Cuyama Valley Groundwater Basin

Draft Groundwater Sustainability Plan: Agency Information, Plan Area, and Communication

April 2019

Figure 1-1 - Cuyama Valley Groundwater Basin
 Cuyama Basin Groundwater Sustainability Agency
 Cuyama Valley Groundwater Basin Groundwater Sustainability Plan
 April 2019

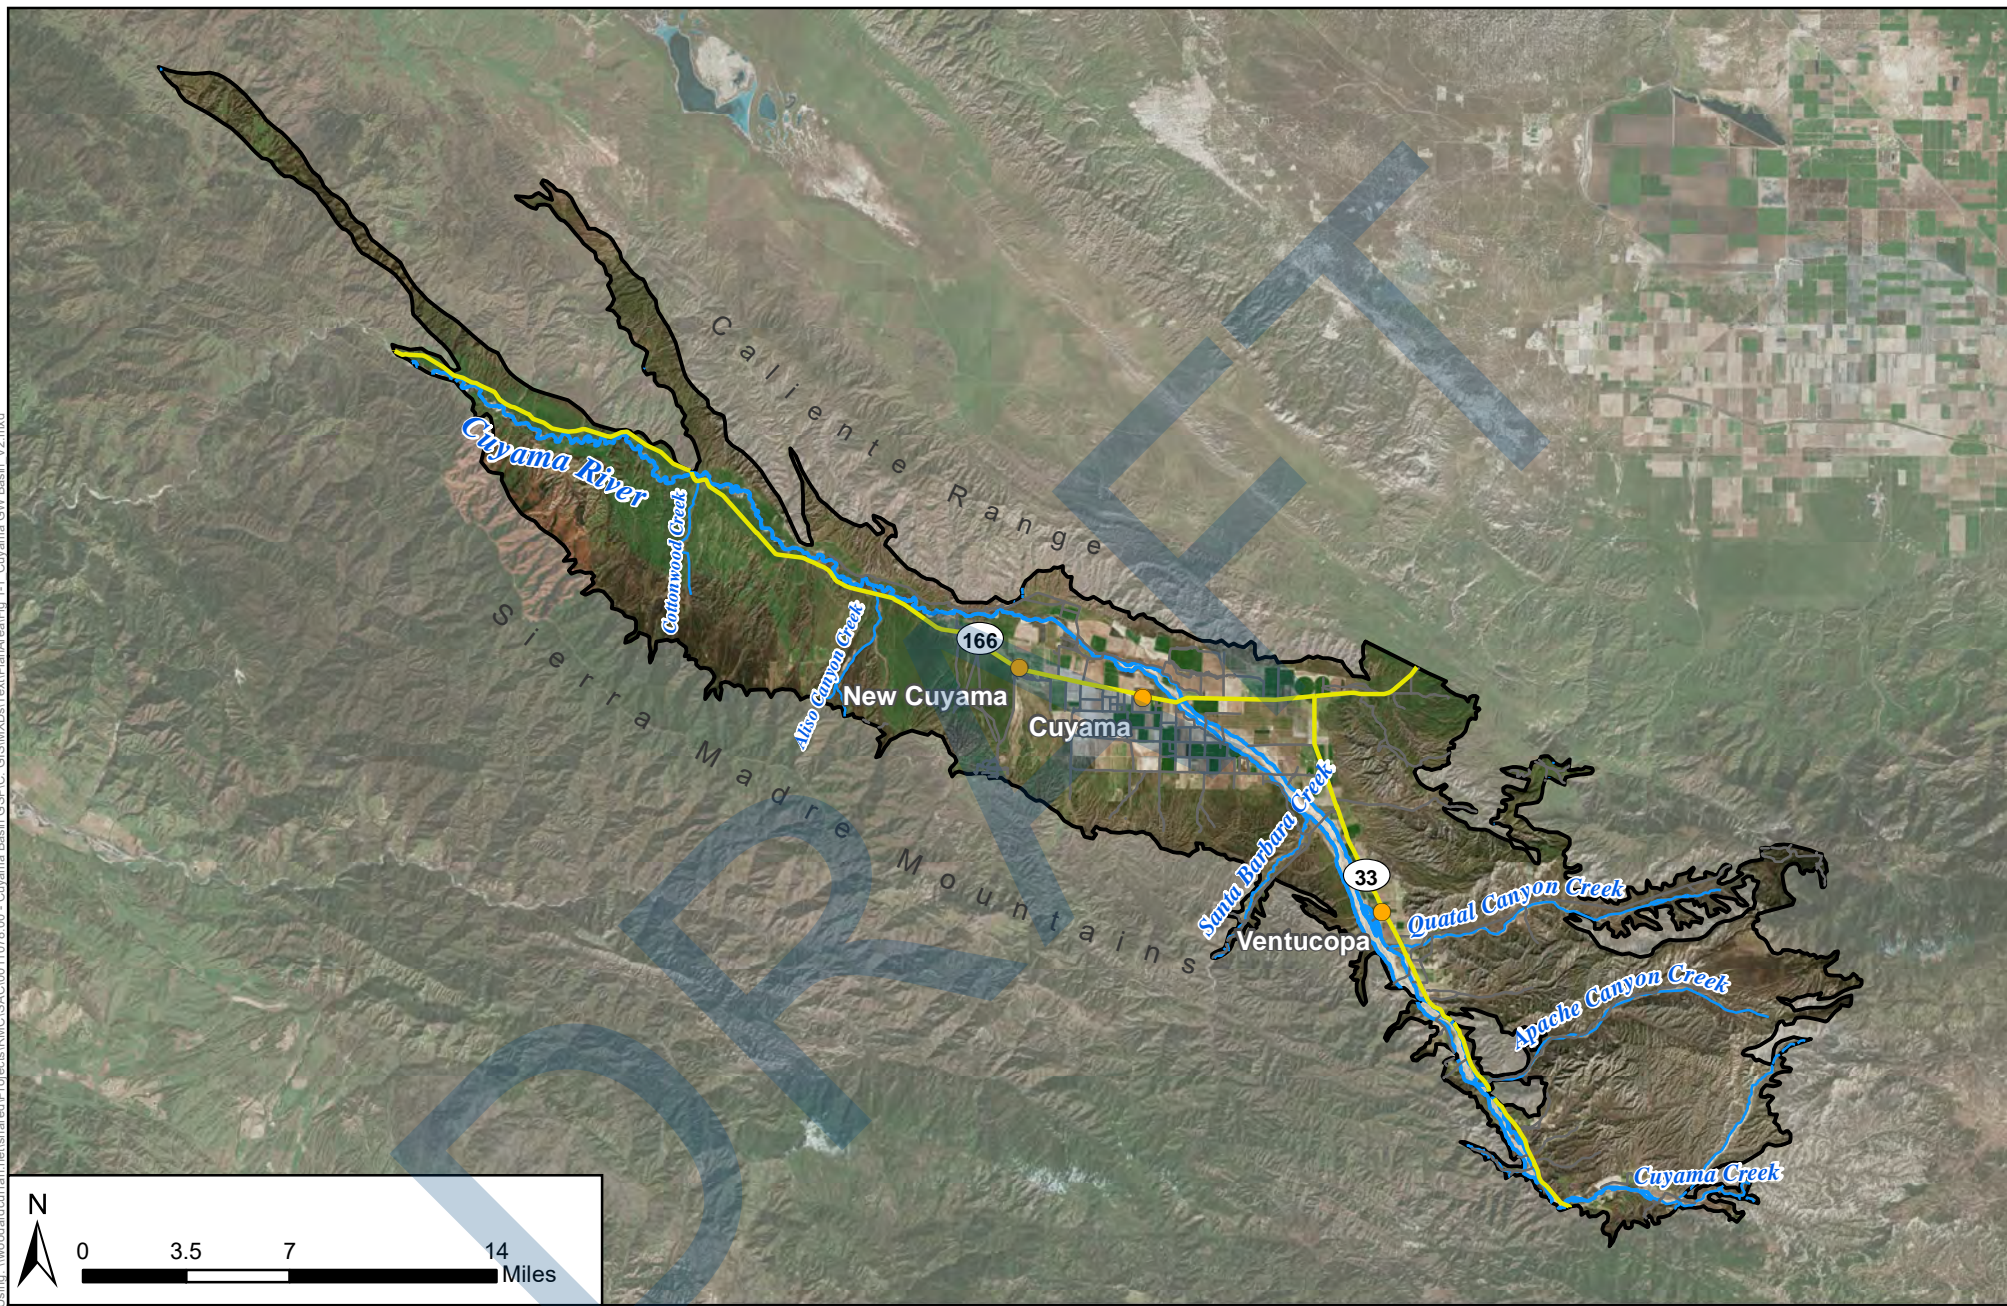
39	1.2	1	2	It is beneath the Cuyama...	Comment "It is beneath the Cuyama Valley, which is bounded by the Caliente Range to the northwest and the Sierra Madre Mountains to the southeast": these 2 ranges should be shown on the figure.	Labels for these ranges will be added to Figure 1-1.
40	1.3	1	4	The Basin also encompasses...	Comment "Wells Creek": not labeled on figure	Creek labels will be added to Figure 1-1
41	1.3	1	4	The Basin also encompasses...	Comment "Quatal Canyon drainage": not labeled on figure	Creek labels will be added to Figure 1-1
42	1.3	1	4	The Basin also encompasses...	Comment "Cuyama Creek": not labeled on figure	Creek labels will be added to Figure 1-1
43	1.3	2	1	Figure 1-2...	Comment "CBGSA": not mentioned in legend	The legend will be updated to note the CBGSA boundary
44	1.3	4	7	Its jurisdictional coverage...	Edits "Ventura County encompasses has jurisdiction over the southeastern area of the Basin (covering 120 square miles), including the area east of Ventucopa."	Comment accepted

67					Comment on Figure 1-12, Fed and state lands: The state lands in the n/w should be labeled "Carrizo plain ecological reserve" as the wildlife sustainability issues will be important.	Carrizo Plains Ecological Reserve will be added to Figure 1-12 where the map label "State Lands" is currently located
68	1.6.2				Comment: The San Luis Obispo 2014 IRWM Plan presents a comprehensive water resources management approach to managing the region's water resources, focusing on strategies to improve the sustainability of current and future needs of San Luis Obispo County (County of San Luis Obispo, 2014), see note below. • Note that the IRWM Plan was heavily based on the 2012 Master Water Report -- https://slocountywater.org/site/Frequent%20Downloads/Master%20Water%20Plan/	A sentence will be added to Section 1.6.2 to note that the IRWM Plan Update was based on the 2012 Master Water Report.
69	1.2				Comment: Add labels on figure for Caliente Range and Sierra Madre Mountains	Labels for these ranges will be added to Figure 1-1.

70	1.3				Comment: combine Figure 1-1 and 1-2?	Creek labels will be added to Figure 1-1
71	1.3				Label Wells Creek, Santa Barbara Creek, Quatal Canyon, and Cuyama Creek on Figure 1-1	Creek labels will be added to Figure 1-1
72	1.3	2	3	The CBGSA was created..	Edit: Remove "E" from "JEPA"	W&C will confirm the correct acronym.

Figure 1-6 - 1996 Land Use

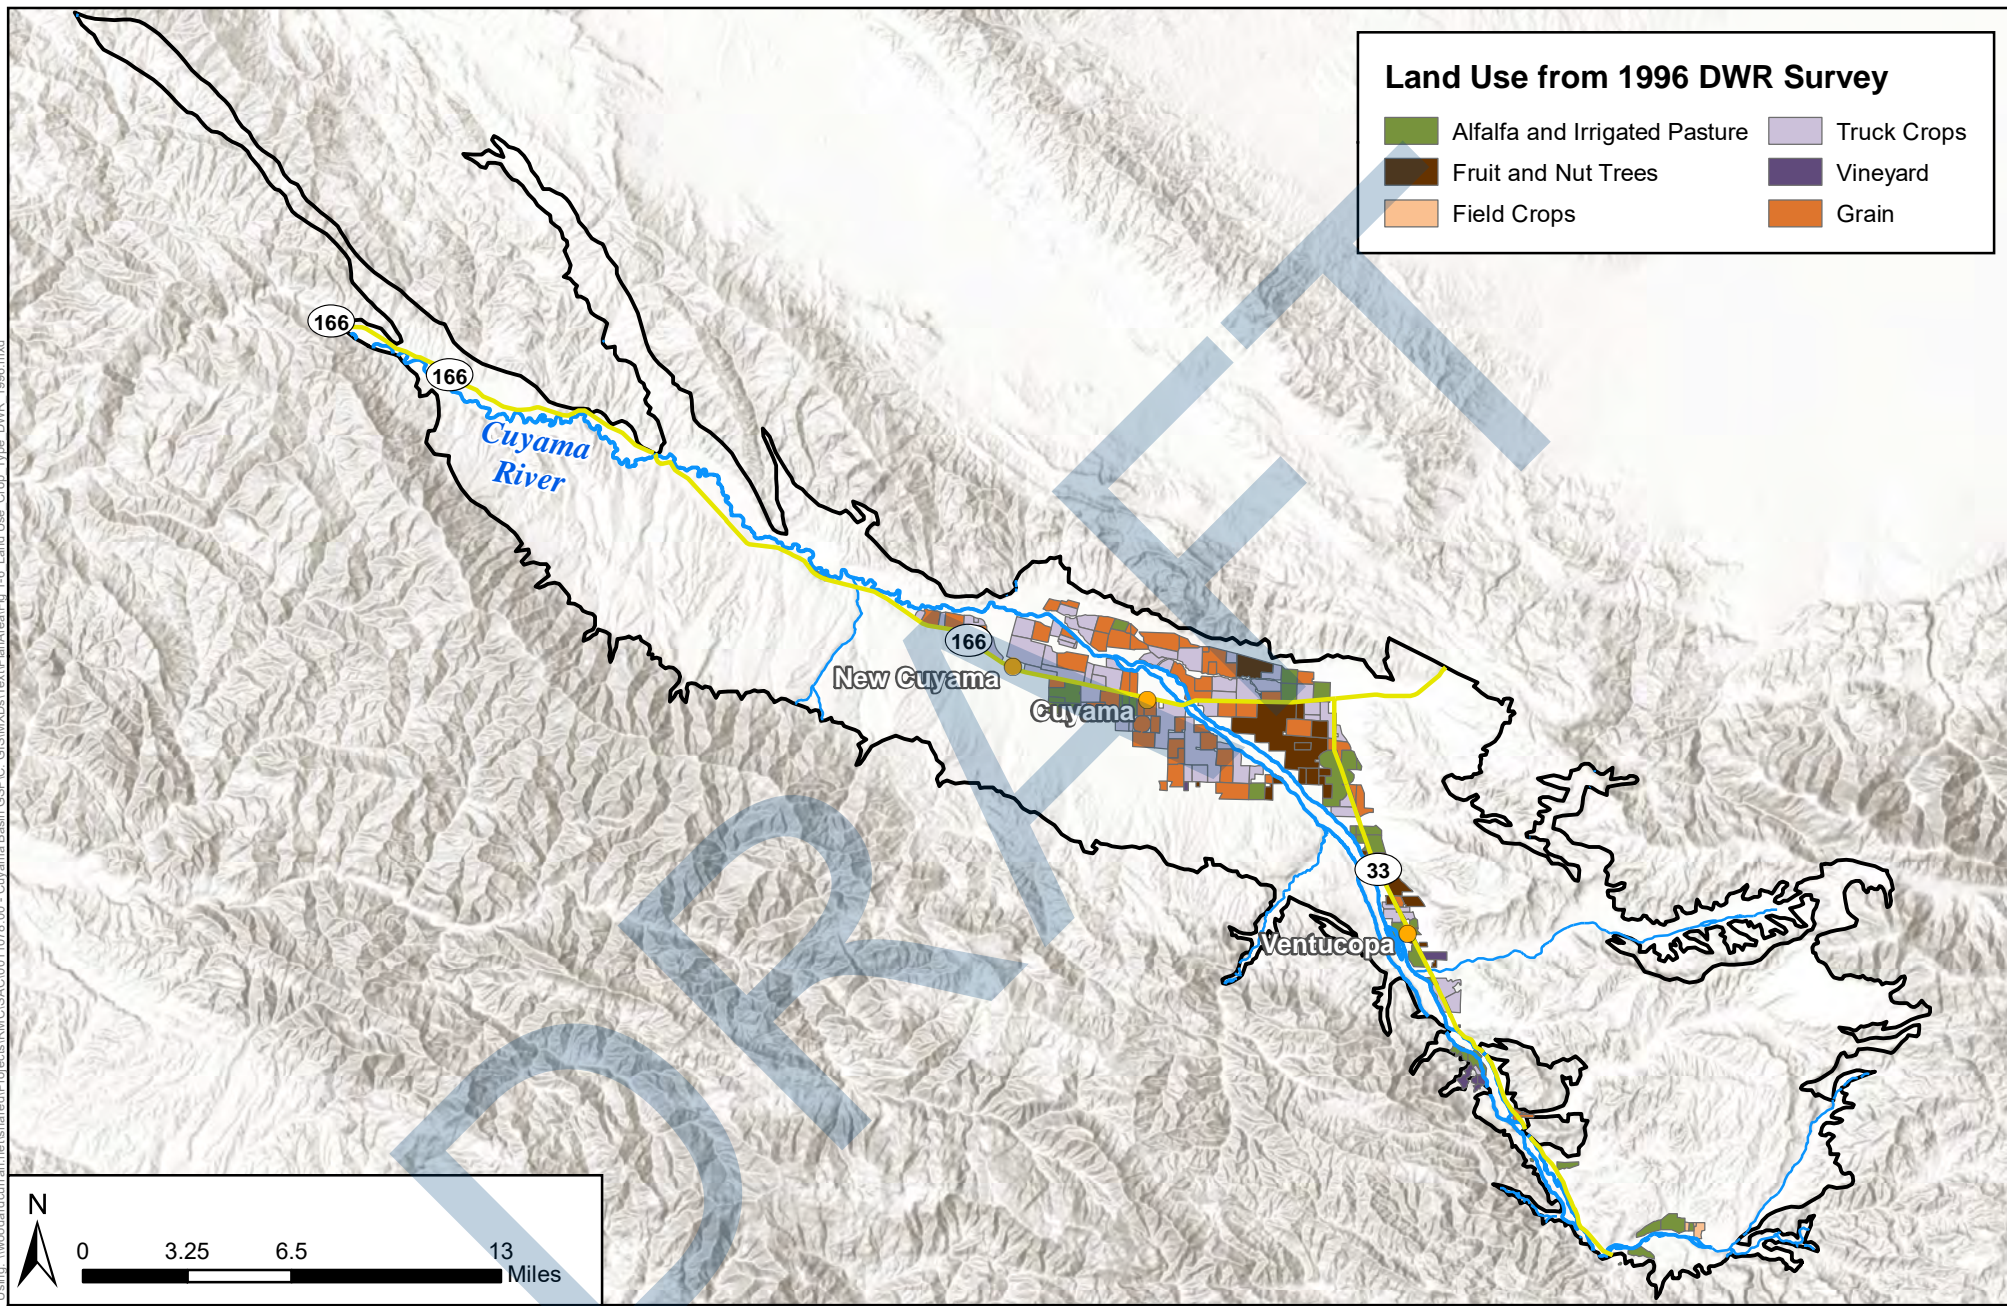
7	1.3	6	1	Figure 1-6 and 1-7...	Comment "... 2014...": How is the Grapevine Capital land use going to be included in this effort?	These figures depict historical land use from before the Grapevine Capital development. For modeling purposes, assumptions about current and future land use will include the Grapevine Capital development as well as other recent changes in land use.
8	1.3	6	---	Crops are generally...	Text Edits ". Crops are generally rotated regularly, and some agricultural area is idle. ,but aAreas that are in active agricultural use produce are primarily miscellaneous truck crops, carrots, potatoes and sweet potatoes, miscellaneous grains and hay, and grapes. Various other crop types are produced in the Basin as well, such as fruit and nut trees, though at smaller production scales.	Comment accepted.
9	1.3	7	4	Much of the surface water...	Comment "figure.": Color scheme between the legend and map appear to be different. Some irrigated lands appear to not have a water use	The current background map shows land uses that were not present in 2014. The background map will be replaced to avoid color confusion.

77	1.3	6			Comment on Figure 1-6 and 1-7: Show all Ag? Cattle Grazing, pastures, and federal and state land. From Landuse. New Figure?	These land use datasets only show irrigated agricultural lands and therefore do not include non-irrigated range and pasture land. However, water use from these other land areas will be accounted for in the numerical model and water budget as part of the GSP. Federal and State Lands are shown in Figure 1-12.
78	1.3	7		Figure 1-8 shows...	Comment on whole paragraph: Capture all ag? Any diminimis users?	These land use datasets only show irrigated agricultural lands and therefore do not include non-irrigated range and pasture land. However, water use from these other land areas will be accounted for in the numerical model and water budget as part of the GSP.
79	1.3	7		Figure 1-8 shows...	Comment "Pastureland, which may not be...": Can you add this infor? New figure?	These land use datasets only show irrigated agricultural lands and therefore do not include non-irrigated range and pasture land. However, water use from these other land areas will be accounted for in the numerical model and water budget as part of the GSP.
